**WIGLEY RD. TRACT
RESIDENTIAL COMMUNITY
ZONING PLAN**

PETITION NO: Z-56

ZONING COMMENTS:

STORMWATER MANAGEMENT COMMENTS

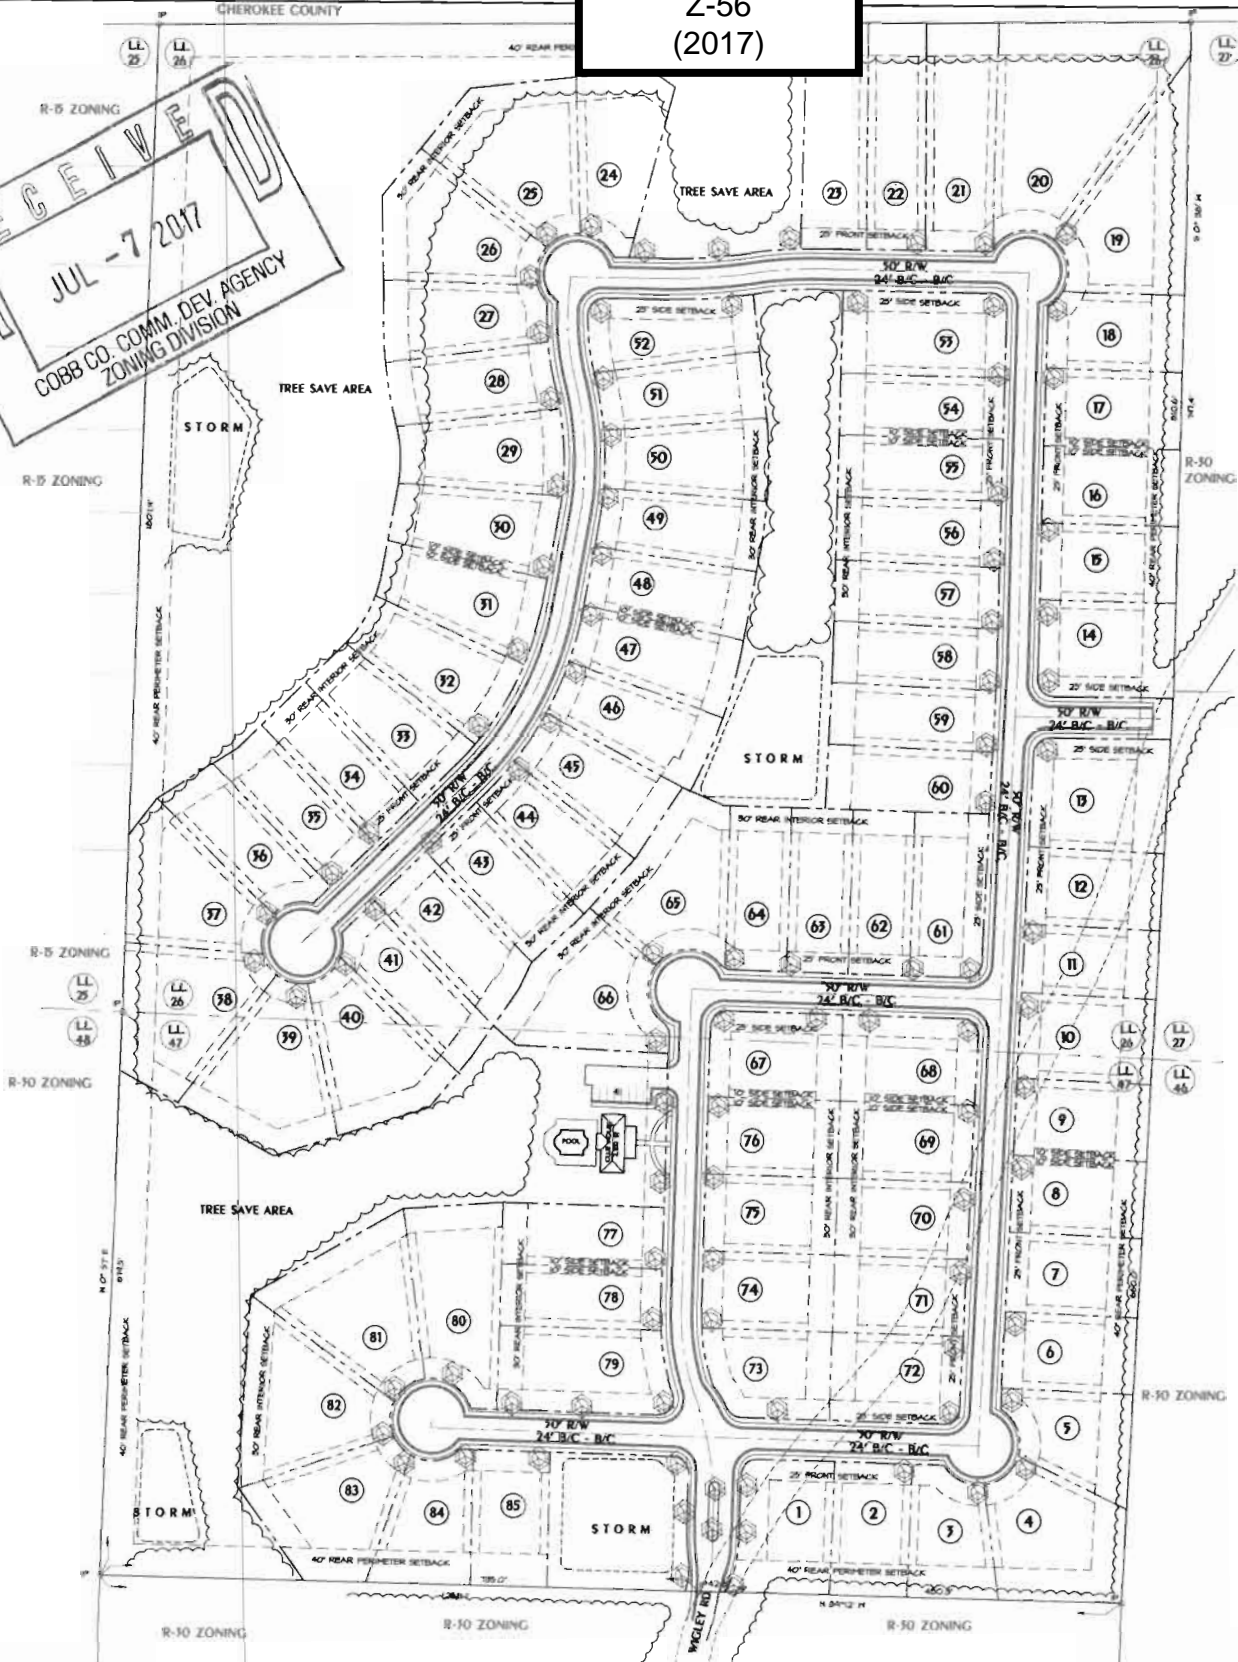
1. This site is located on the northern portion of Wigley Road. The site lies on a steep ridgeline and drains in three directions. The majority of the site (40%) drains to the south roughly parallel to Wigley Road. Approximately 35% of the site drains to the northeast along Wigley Road into Cherokee County. The remaining 25% of the site drains to the west into and through the adjacent Falcon Crest Subdivision. The site is predominately wooded with steep slopes ranging from 12 to 40%. The site layout needs to be sensitive to the steep topography. A preliminary rough grading plan should be provided to verify feasibility of the proposed layout.

2. Stormwater management for the site will be provided by multiple onsite detention ponds. The pond locations may need to be adjusted to limit grading required and to adequately control runoff from the development.

3. As indicated in the Downstream Conditions comments above, there is an existing lake located approximately 300 feet downstream. A pre- and post-development sediment study will be required to document any sediment impacts to this lake. Elevated onsite erosion control measures will be required due to the steepness of the site.

4. A downstream headwater pool analysis will be required for the existing receiving culvert in Falcon Crest S/D to verify no adverse impact. The basement at 2254 Hawk Trace is located significantly below the low point of the road.

Wigley Drive is classified as a local and according to the available information the existing right-of-way does not meet the minimum requirements for this classification.

The existing Wigley Road right-of-way will need to be abandoned prior to Land Disturbance Permit.
